HISTORIC AND DESIGN REVIEW COMMISSION

November 06, 2019

HDRC CASE NO: 2019-607
ADDRESS: 221 MUNCEY
LEGAL DESCRIPTION: NCB 1660 BLK H LOT S 50FT OF 7,8 & S 50FT OF E 16.2FT OF 6
ZONING: R-6, H
CITY COUNCIL DIST.: 2
DISTRICT: Dignowity Hill Historic District
APPLICANT: Octavio Viramontes/Resco
OWNER: Hacam Properties LLC
TYPE OF WORK: New construction of a one-story single-family structure
APPLICATION RECEIVED: October 08, 2019
60-DAY REVIEW: December 7, 2019
CASE MANAGER: Edward Hall
REQUEST:

The applicant is requesting a Certificate of Appropriateness for approval to construct a 1-story, single family residential structure on the vacant lot at 221 Muncey, located within the Dignowity Hill Historic District.

CONCEPTUAL VIEW

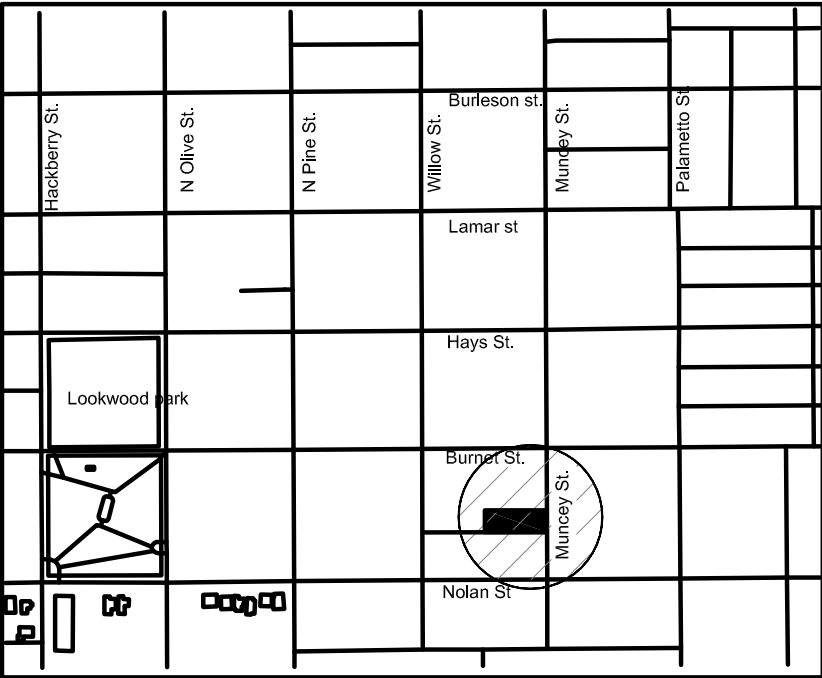
- m. **ARCHITECTURAL DETAILS** – Generally, staff finds the proposed details to be appropriate and consistent with the Guidelines; however, staff finds that an increased roof pitch may result in a more proportionate ratio relating to wall height, roof height and roof pitch. The submitted rendering features a roof proportion that is appropriate.

- ii. That the applicant increase the roof pitch to result in a more proportionate ratio relating to wall height, roof height and roof pitch.
- iii. That the applicant apply for approval of the non-permitted rear accessory, or demolish it.
